901 NORTH CAPITOL STREET NE ZONING COMMISSION SUBMISSION

PREVIOUSLY APPROVED - ZC CASE NO. 21-09

901 NORTH CAPITOL STREET NE ZONING COMMISSION SUBMISSION : JUNE 16, 2023

NORTH BUILDING ELEVATION : A19 - REV

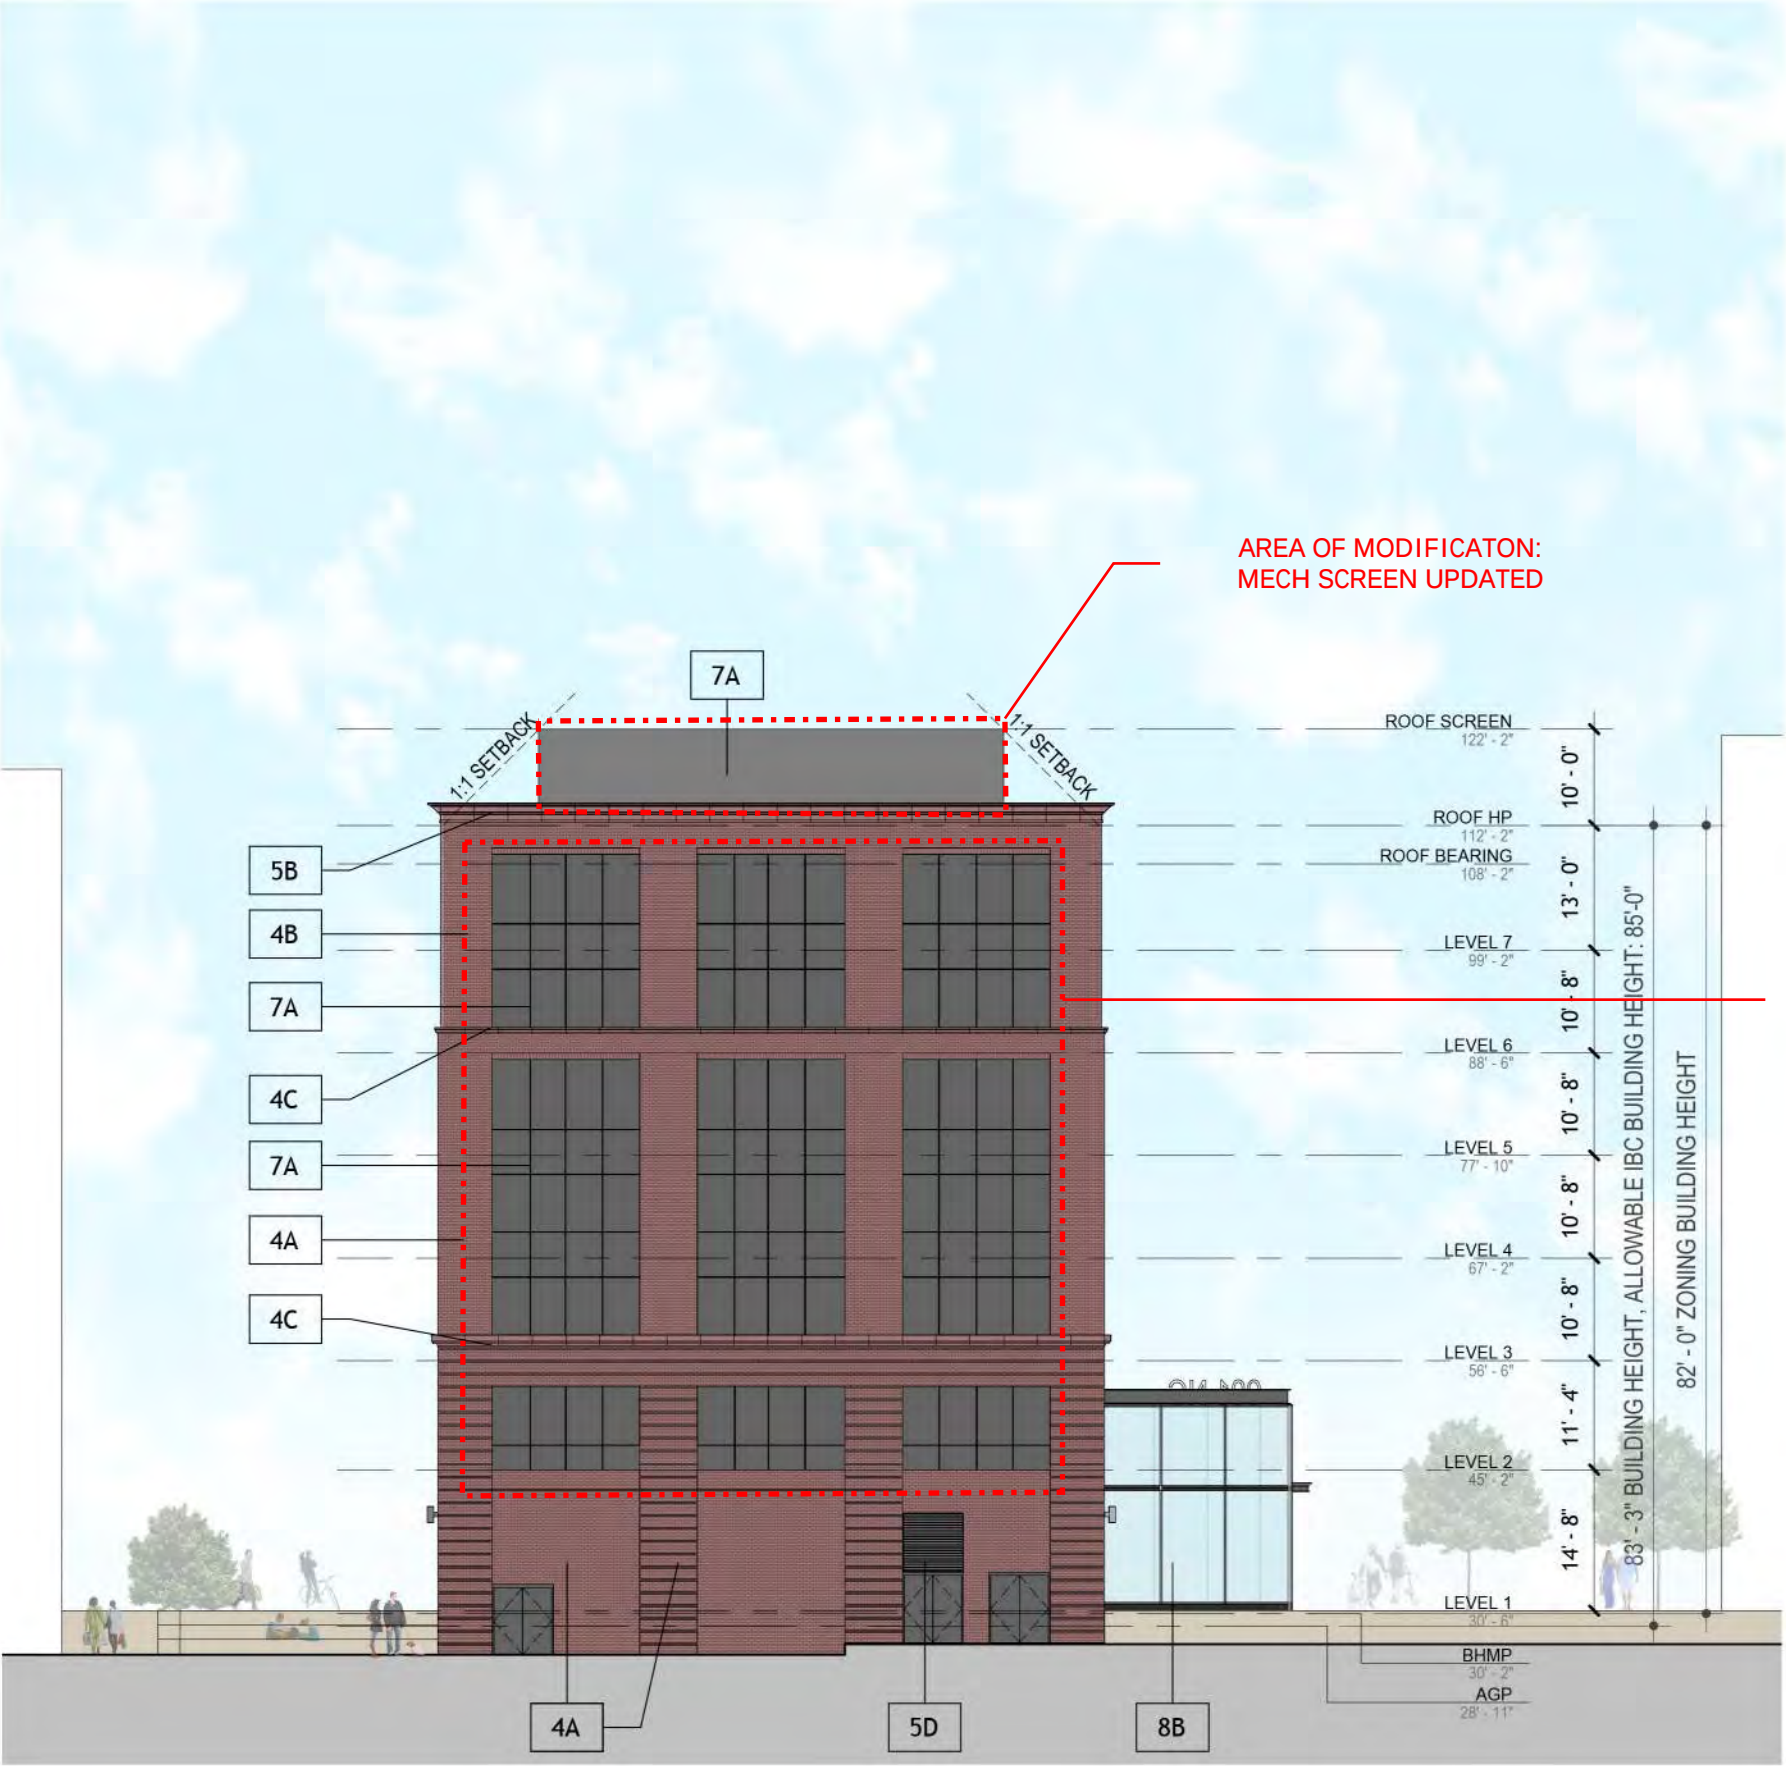
AREA OF MODIFICATION: SIGNAGE ZONES UPDATED & DOORS ADDED

BUILDING SECTION AA : A22 - REV

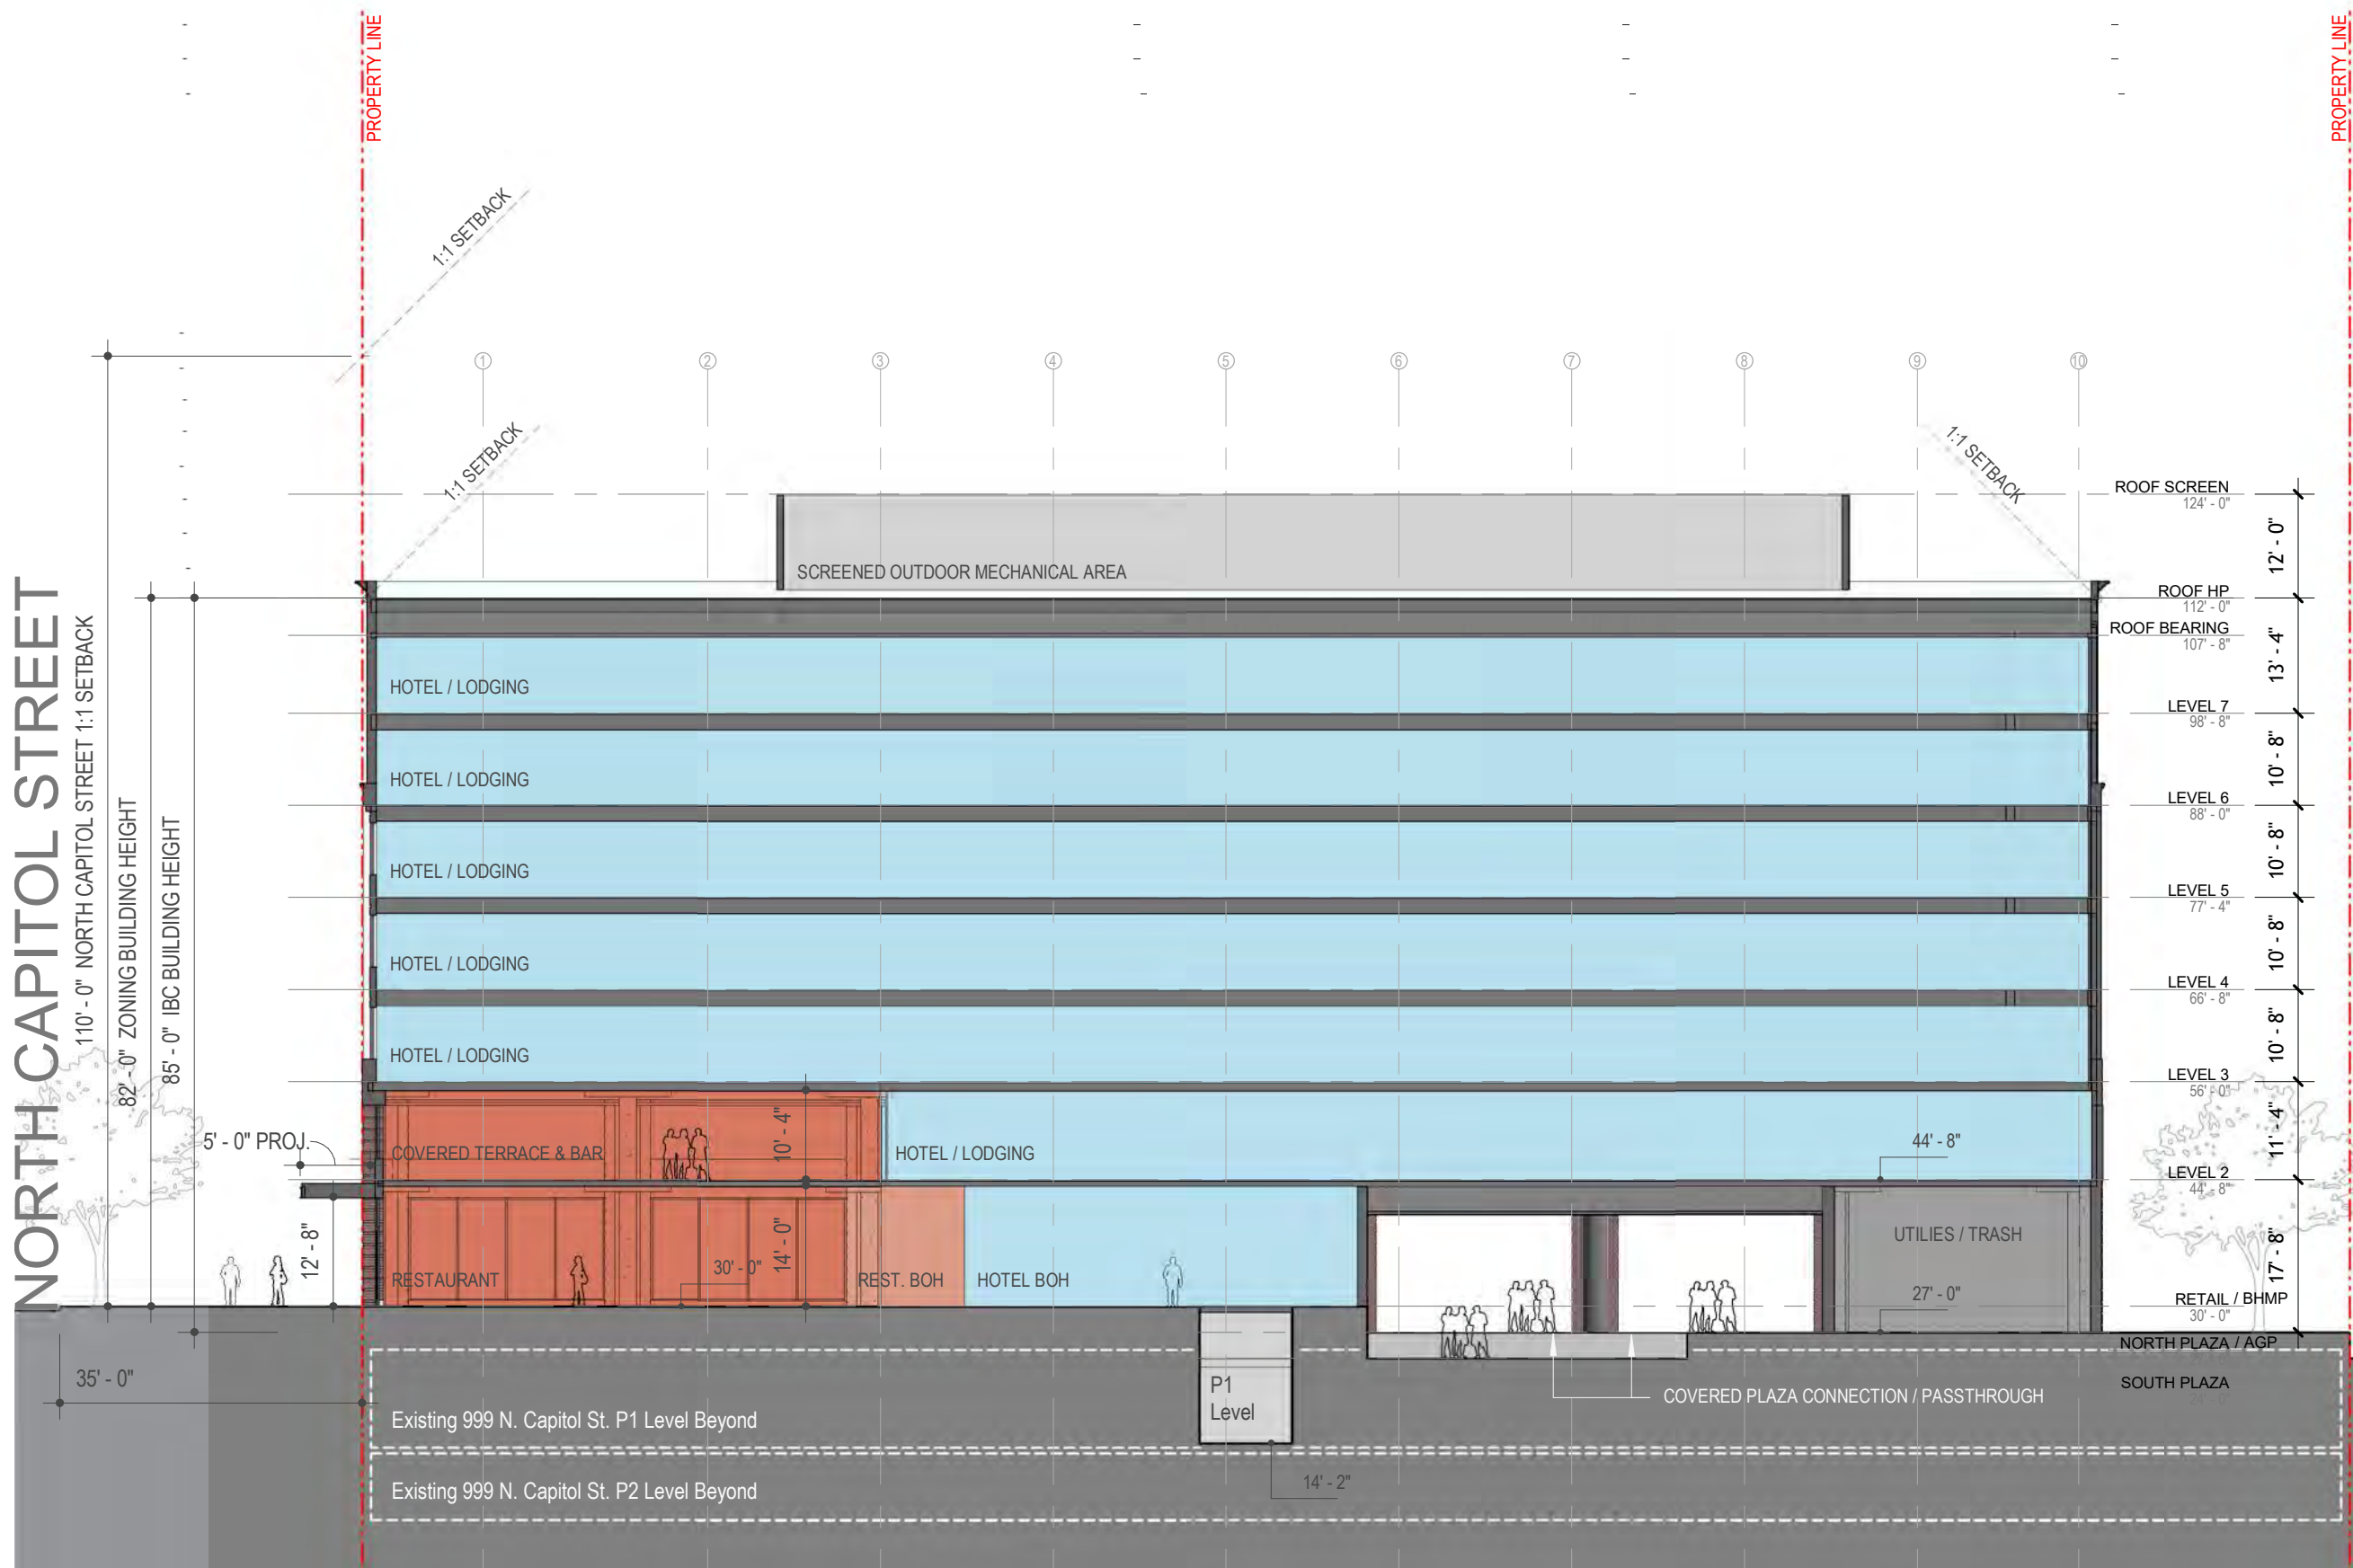
AREA OF MODIFICATION:
MECH SCREEN UPDATED

AREA OF MODIFICATION:
RETAIL REMOVED FROM
LEVEL 2

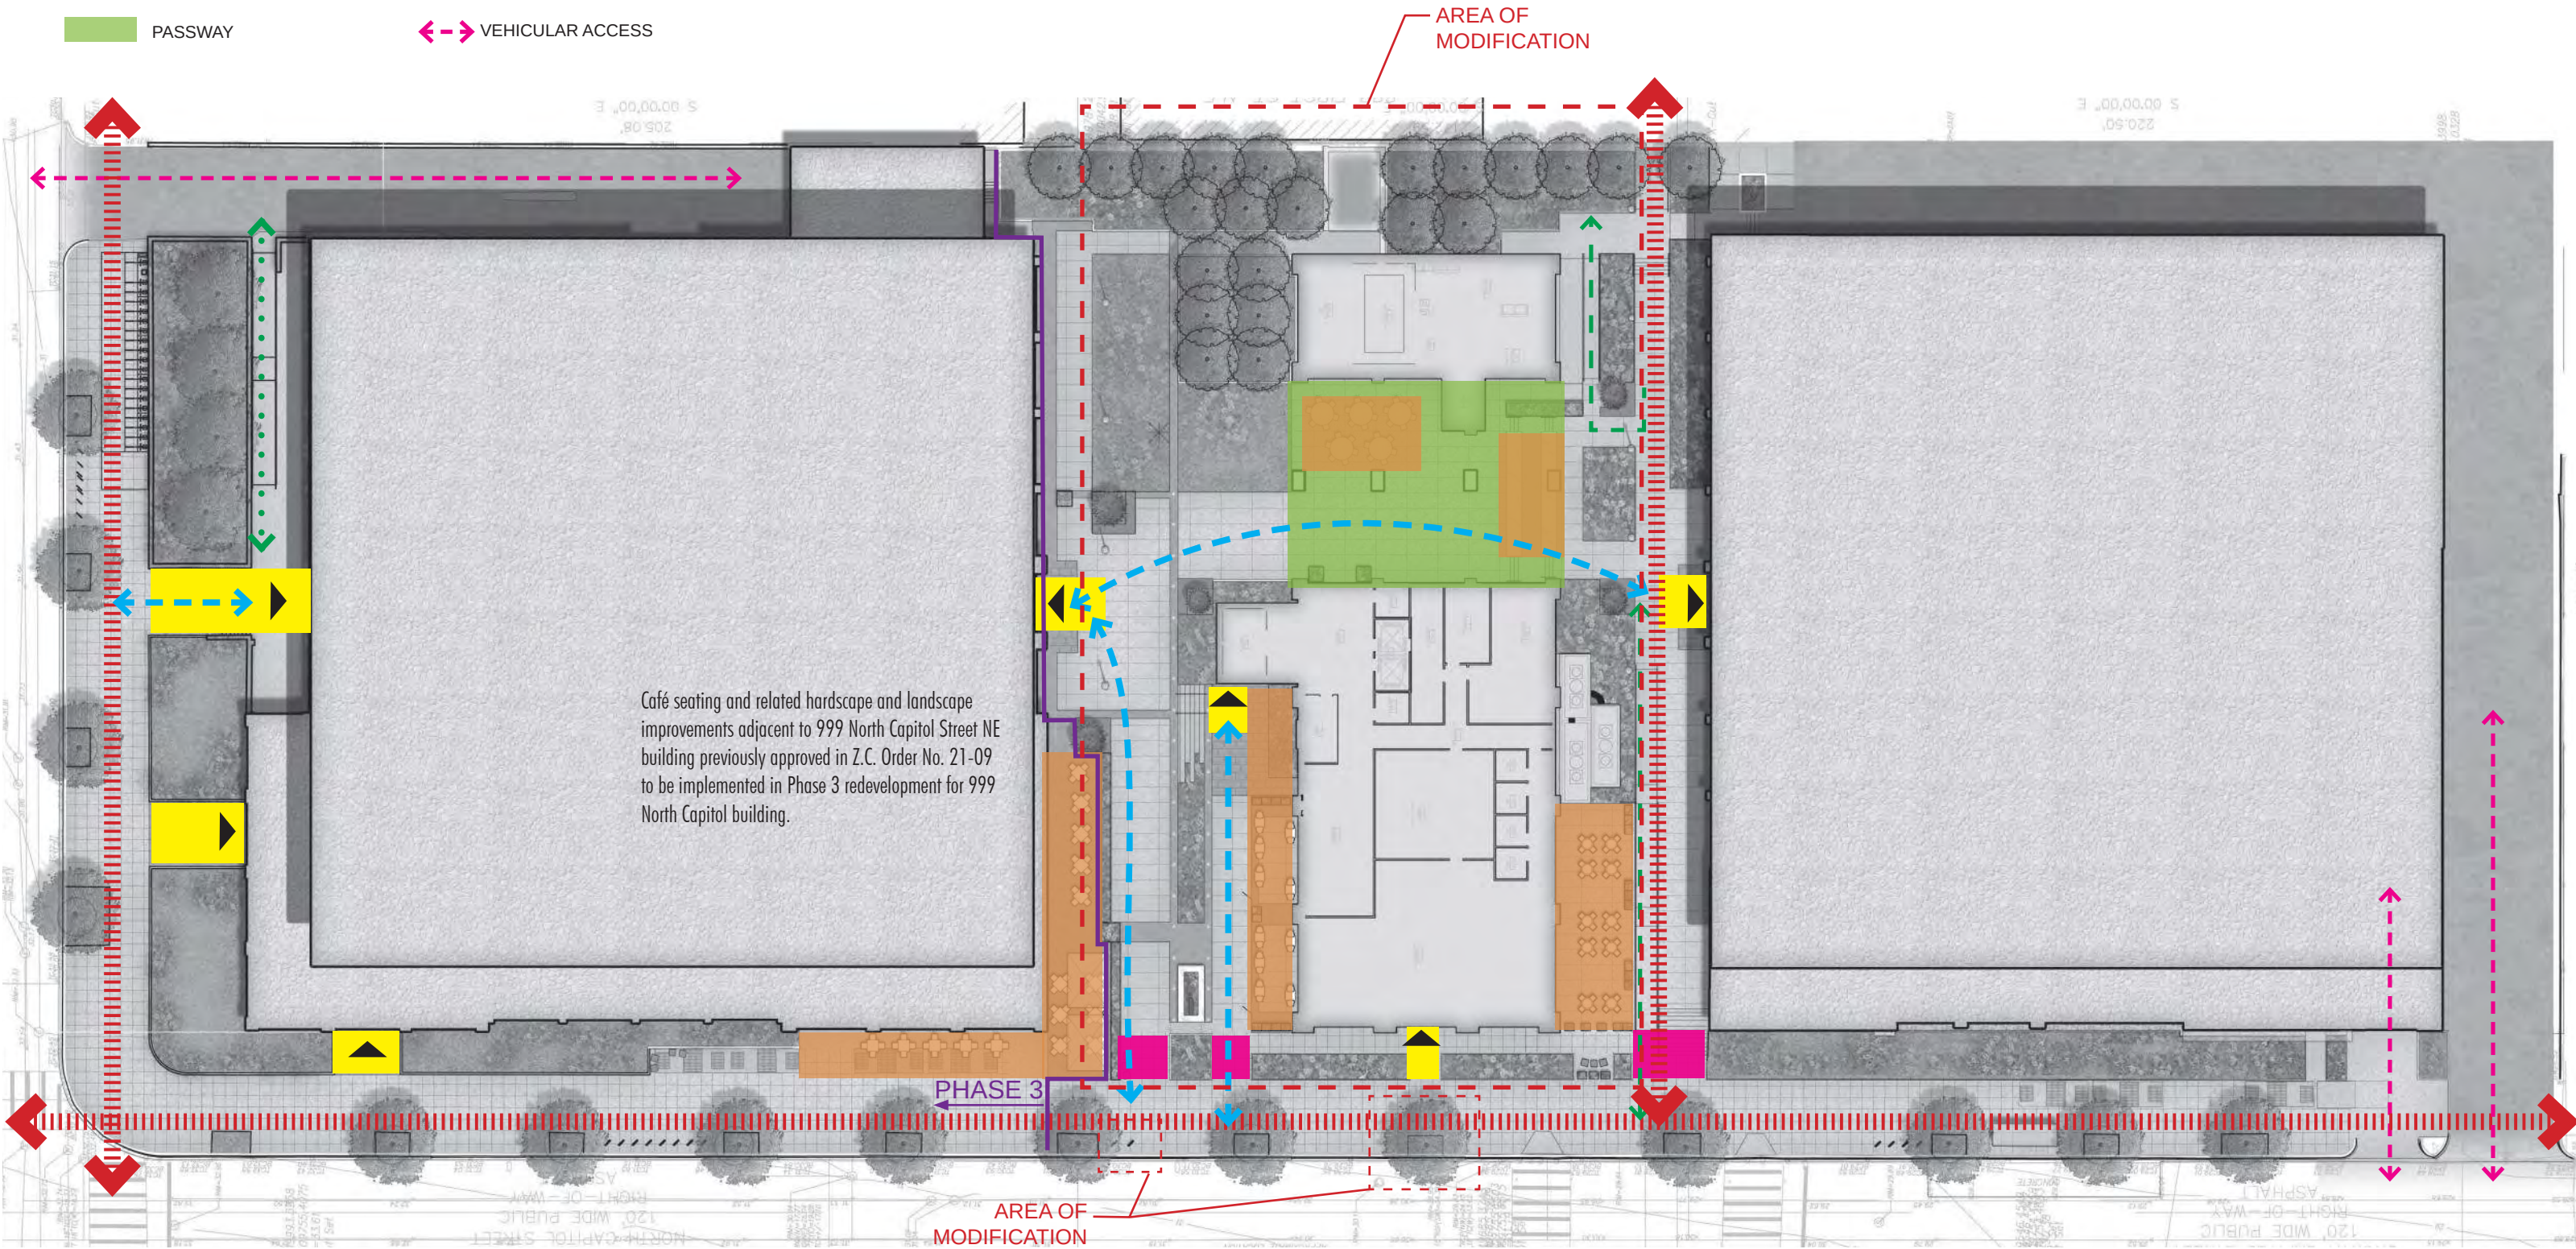
Modifications:
-Plaza entrance is limited by planters.
